MEMORANDUM

JOB NAME: #17-254022 FA adidas NACCO Warehouse
Portland, OR

RE: Scope and Submission Changes

RE: Scope and Submission Changes

1 FIRST FLOOR EGRESS PLAN
G-101 1/16" = 1'-0"

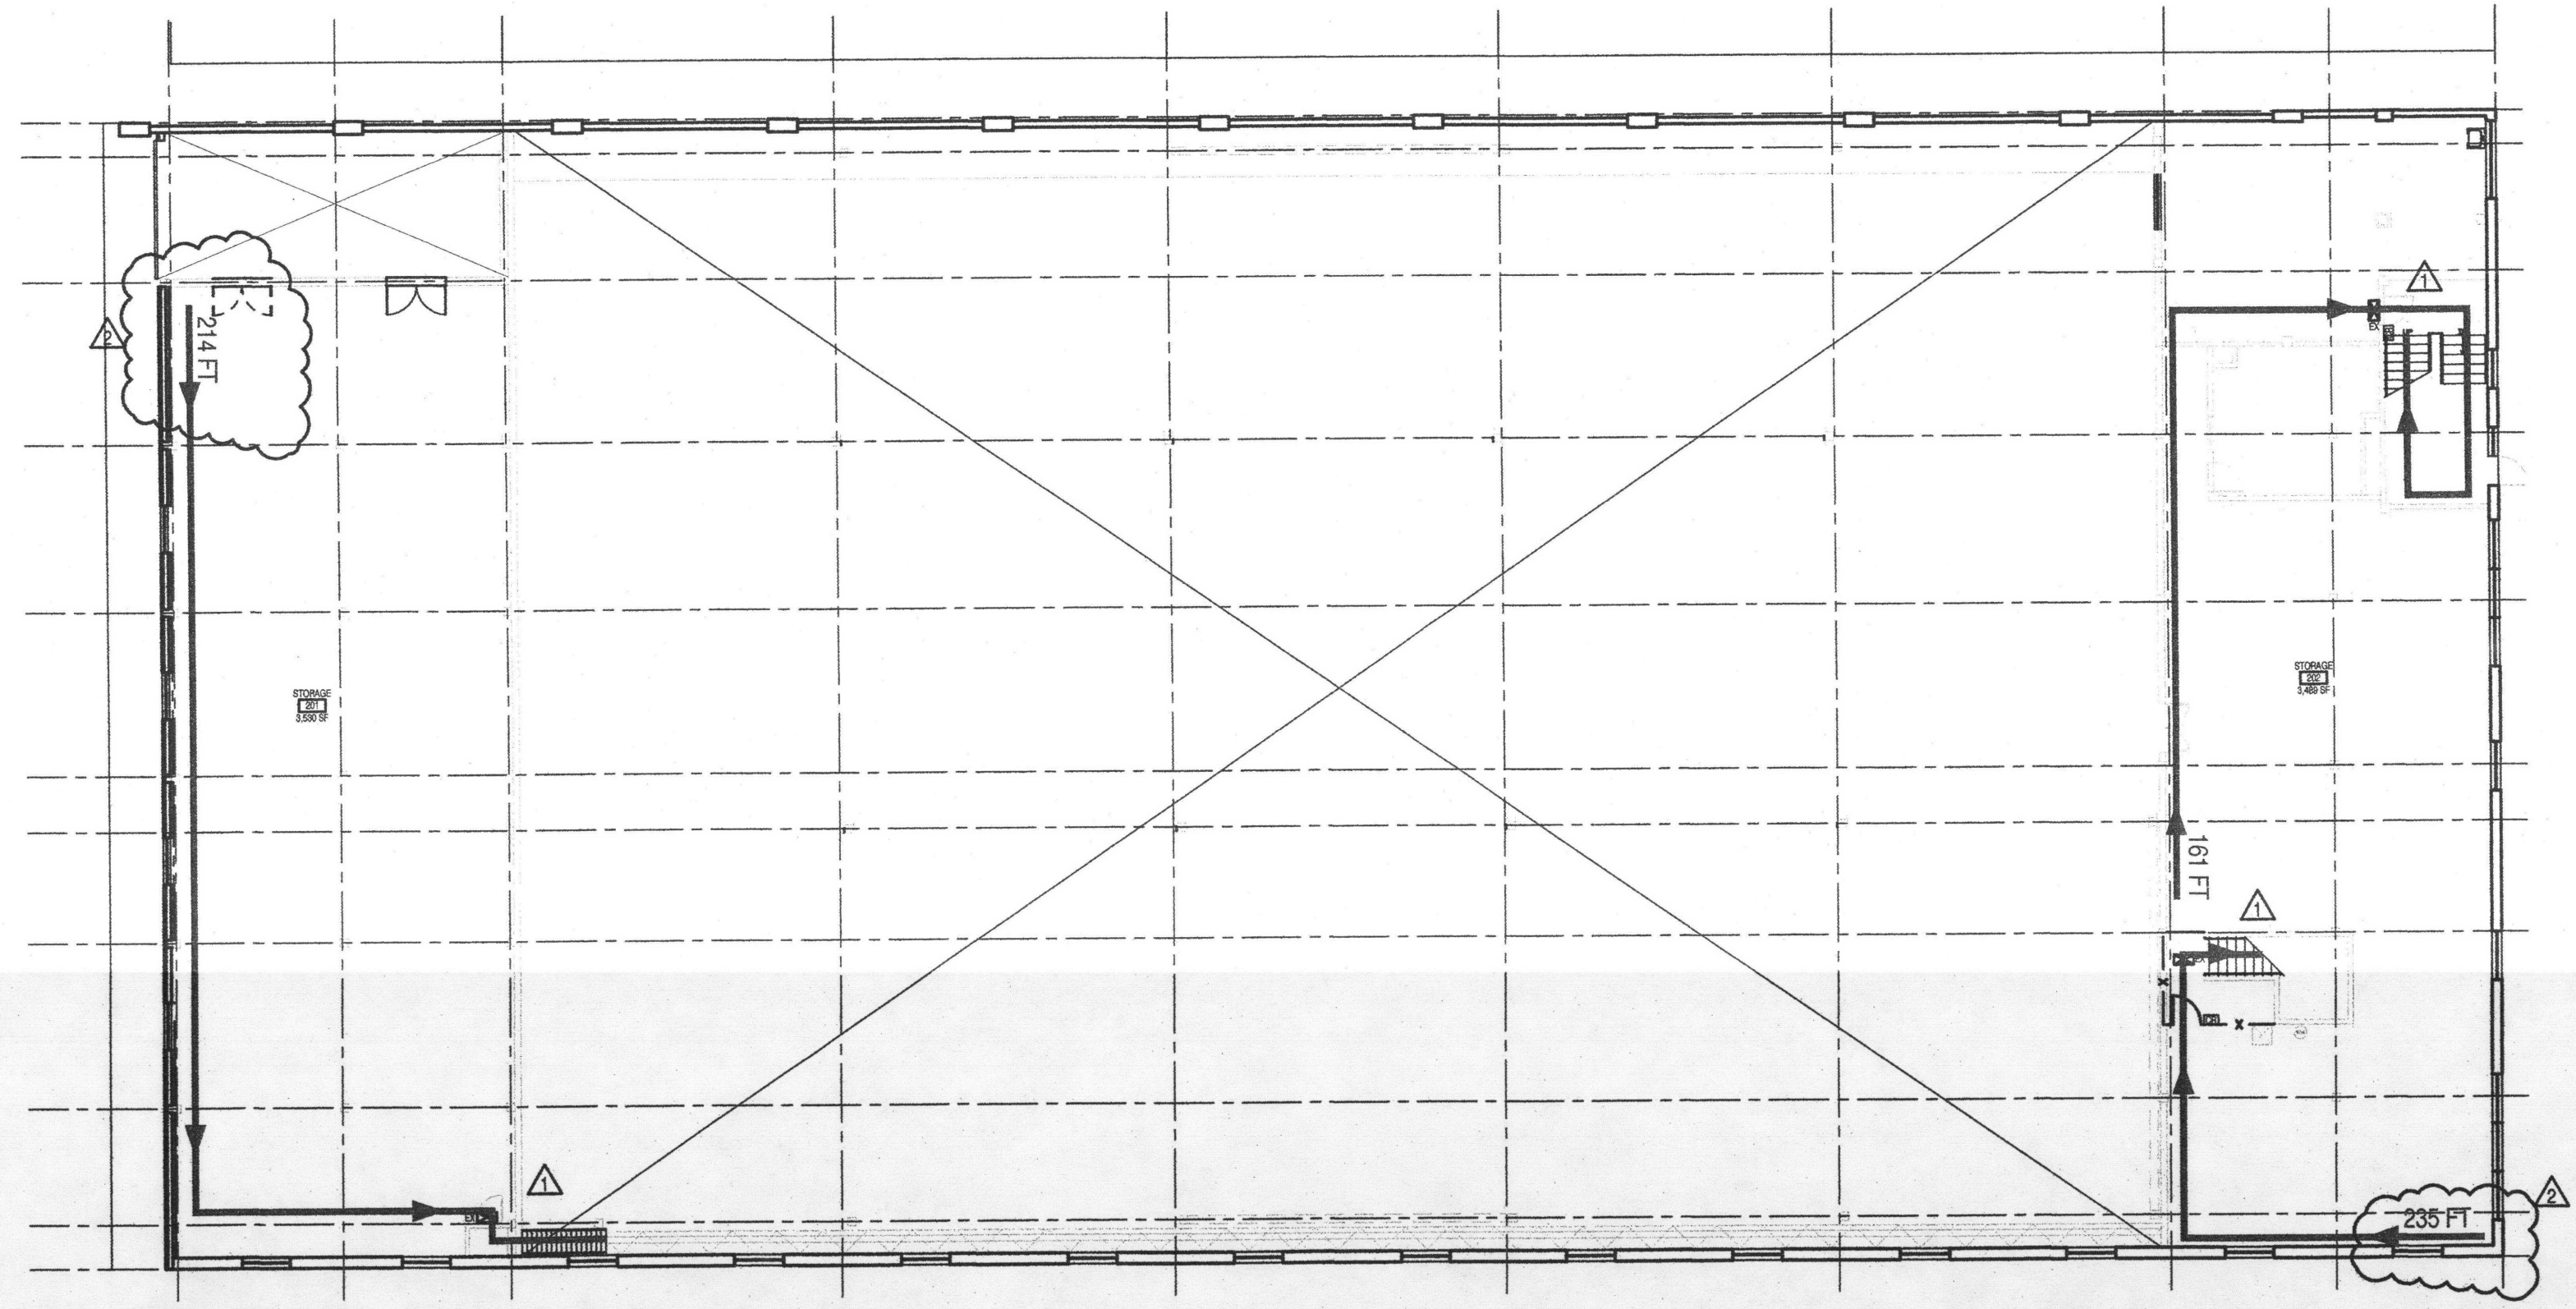
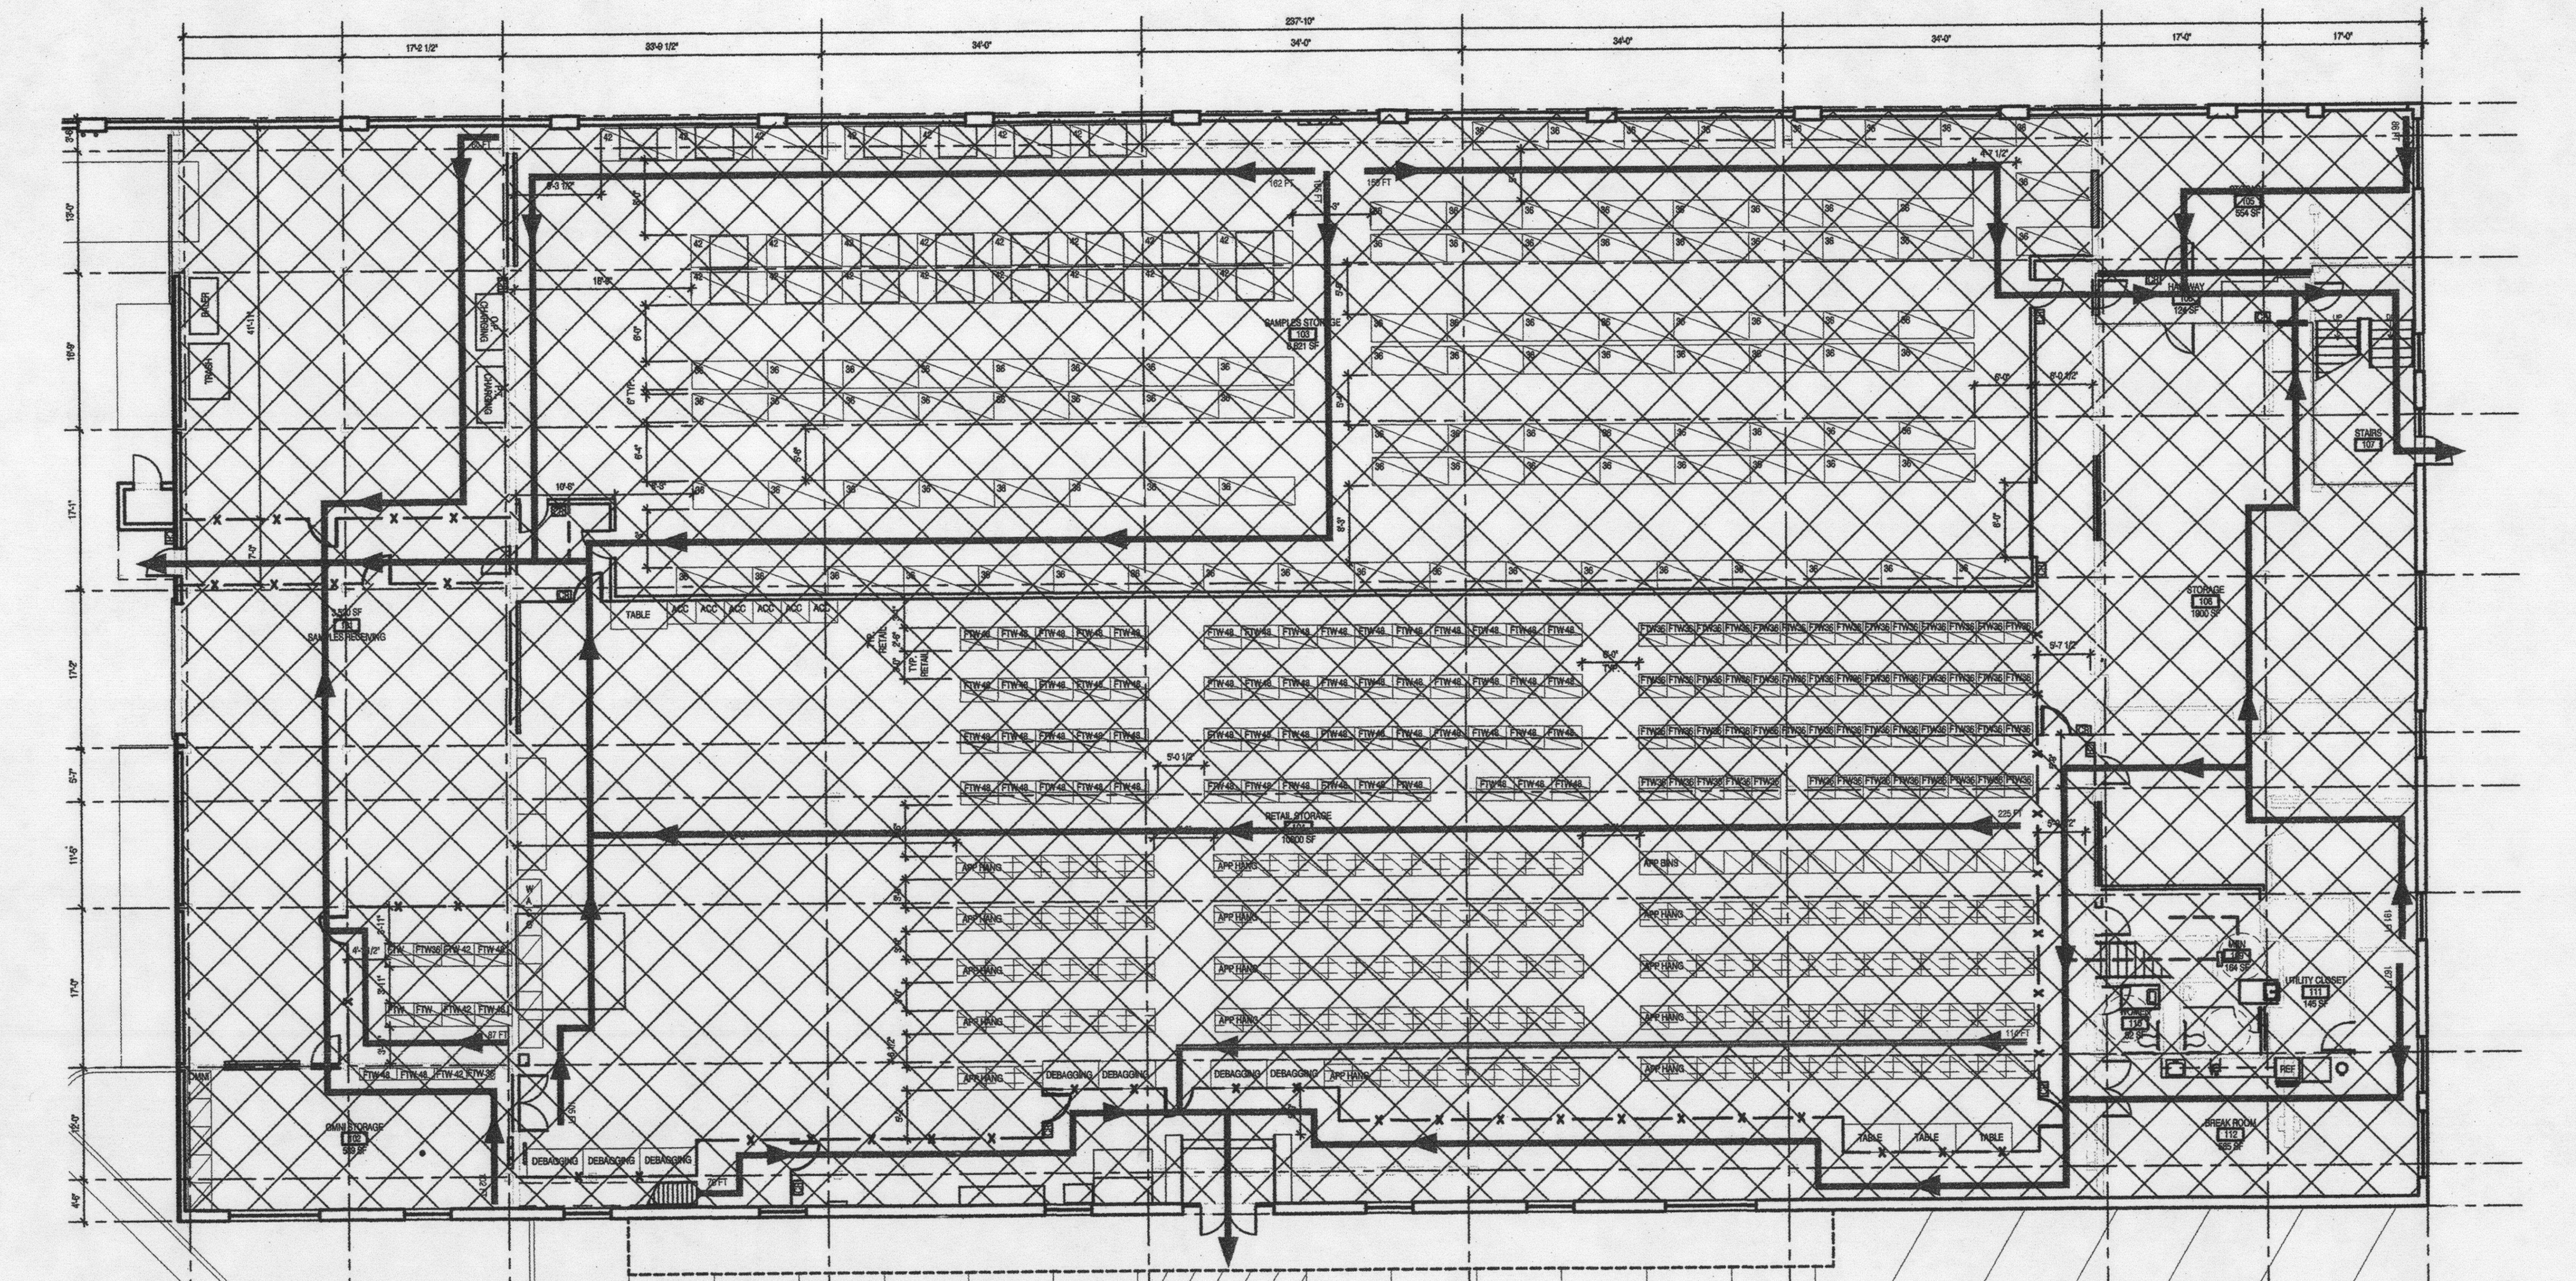
G-101	Modified Egress, calculations
A-101	Modified Parking, parking calculations
A-200	Modified to show full scope
A-202	Modified to show full scope, additional security fence, shelving
A-203	Modified due to scope
A-204	Modified due to scope
A-205	Modified to show full scope
A-206	Modified to show full scope
A-207	Modified to show full scope
A-400	Modified to show full scope, additional security wall
A-500	Removed due to change in security wall
A-600	Modified door schedule
A-700	Modified details
